MONTICELLO NUCLEAR GENERATING PLANT

REQUEST FOR AMENDMENT TO
OPERATING LICENSE NO. DPR-22

License Amendment Request Dated May 12, 1986

1. Offgas System Trip

FIGURE I
OFFGAS FLOW

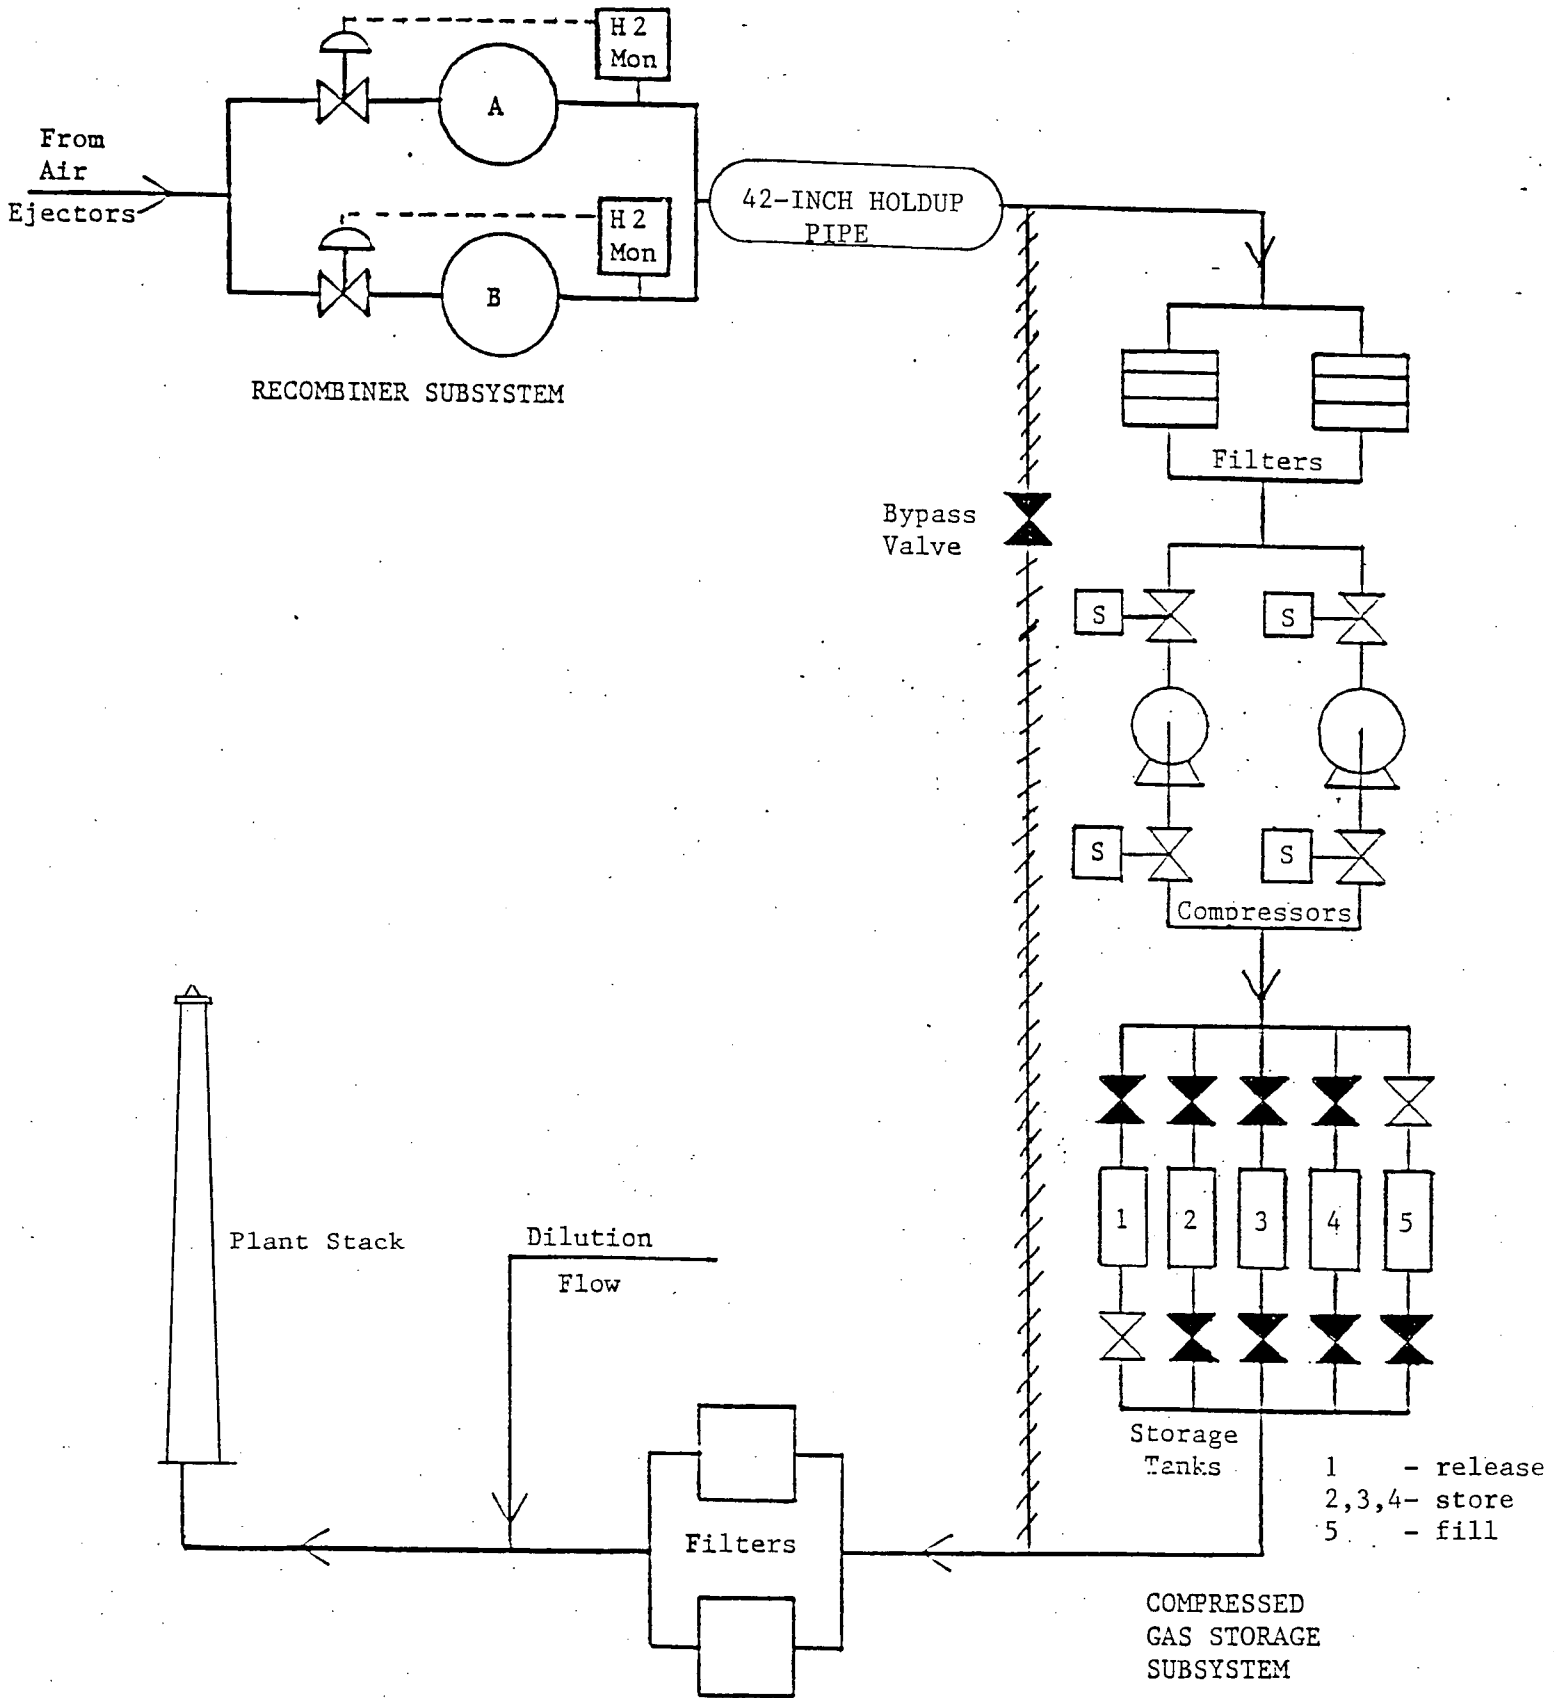
subsystems. The recombiner subsystem functions to recombine the hydrogen and oxygen normally present in the offgas, thus reducing the offgas volume and rendering it non-combustible and safe for compressed storage. The compressed storage subsystem functions to provide additional delay time and removal of additional radioactive particulates and iodine from the gas (Figure I).

FIGURE II
 PROPOSED OFFGAS MODIFICATION

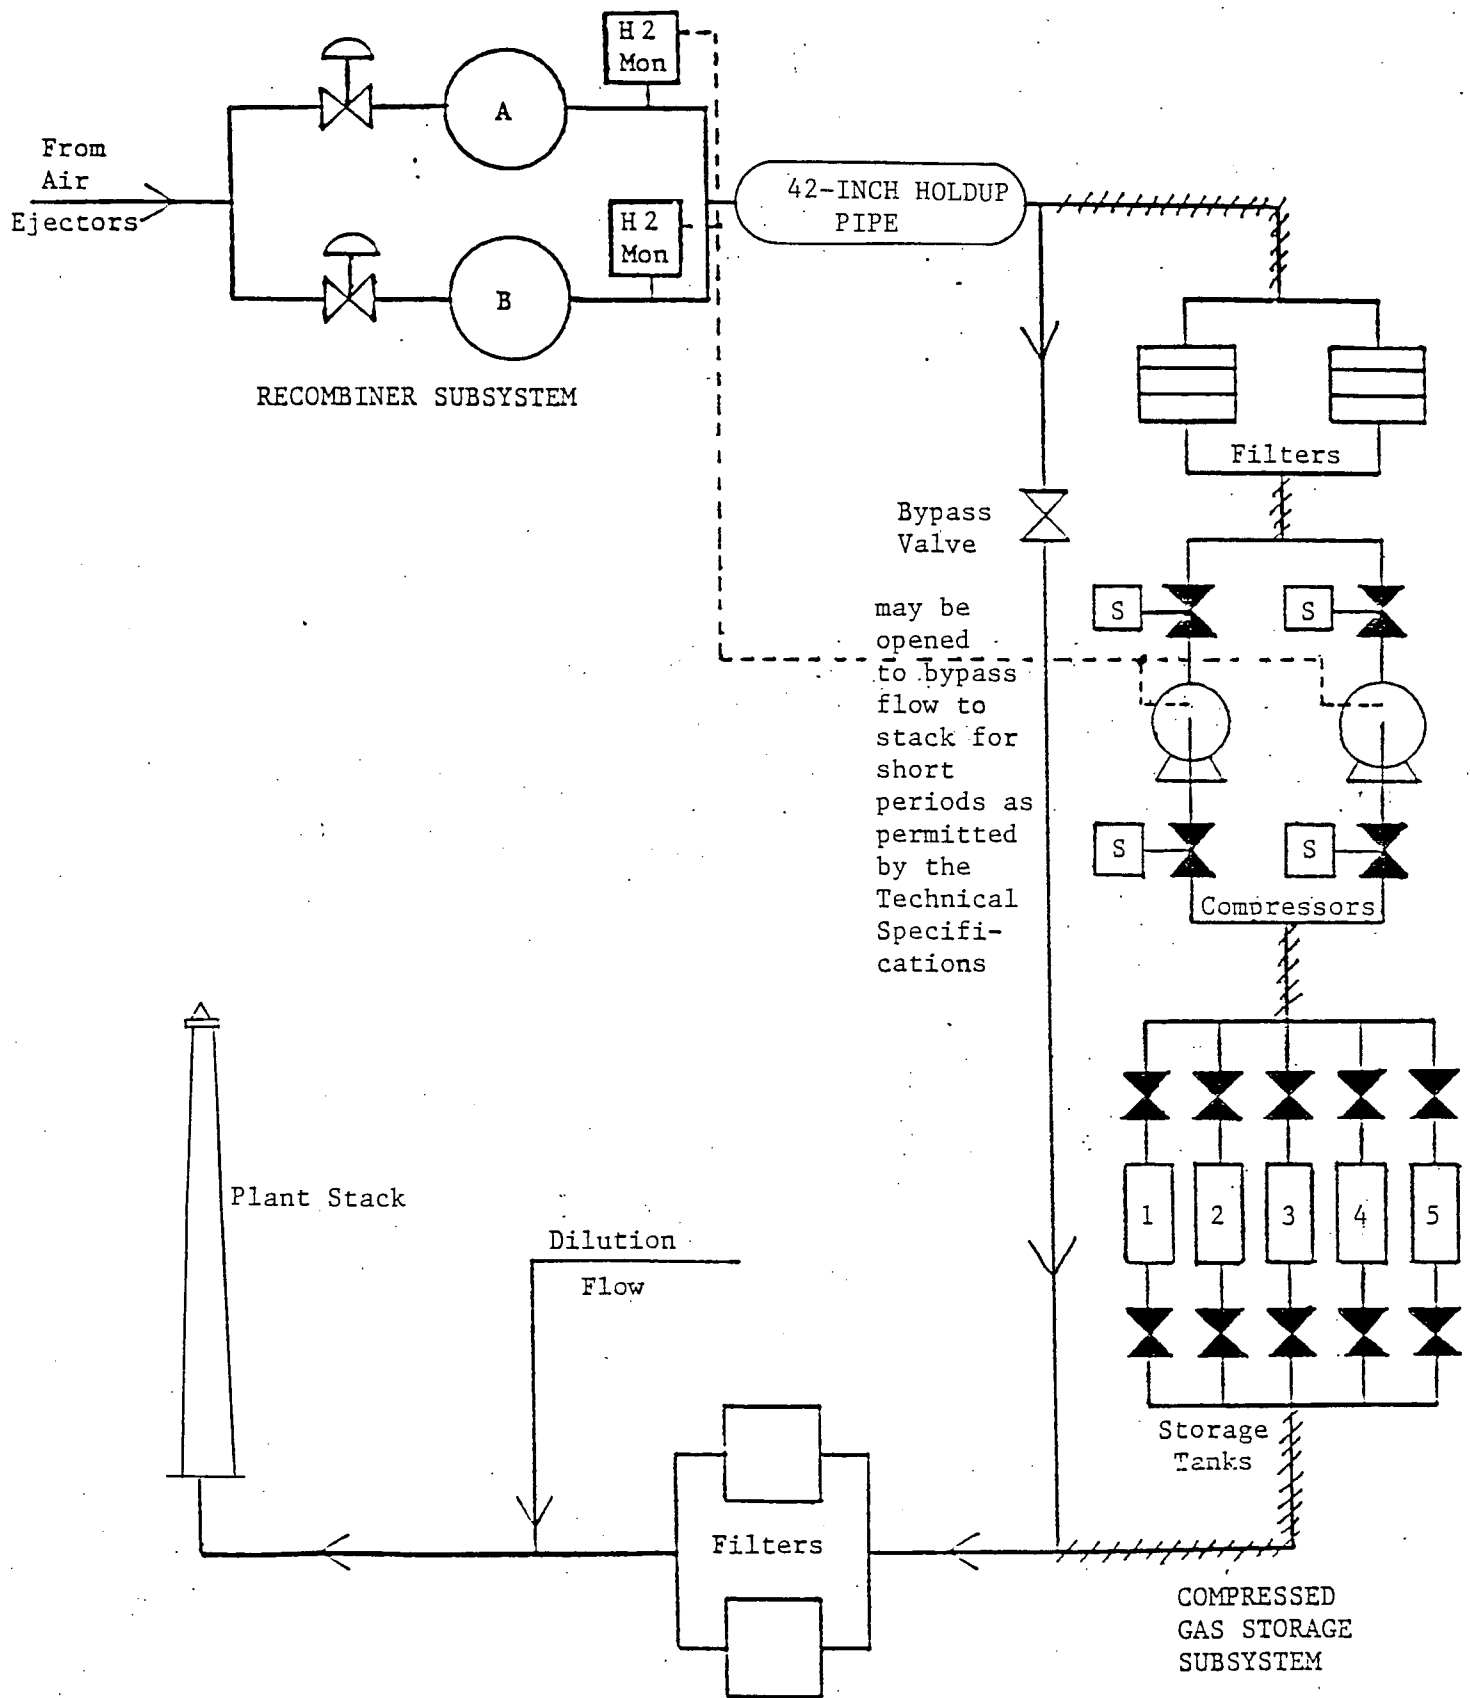
Relocate the hydrogen monitor trip function from the recombiner train trip to the offgas compressor trip, as shown in Exhibit B pages, 198c and 198y.

Removing the hydrogen analyzer trip from the recombiner train trip logic and installing it in the compressor trip logic will increase plant reliability by providing more time for operators to respond to hydrogen monitor trips.

The proposed logic modification would allow offgas flow to continue through the recombiner subsystem to the large 42-inch holdup pipe and stack while investigating hydrogen monitor trips. This reduces the potential of a reactor scram on low condenser vacuum by providing more time for operator action (Figure II).
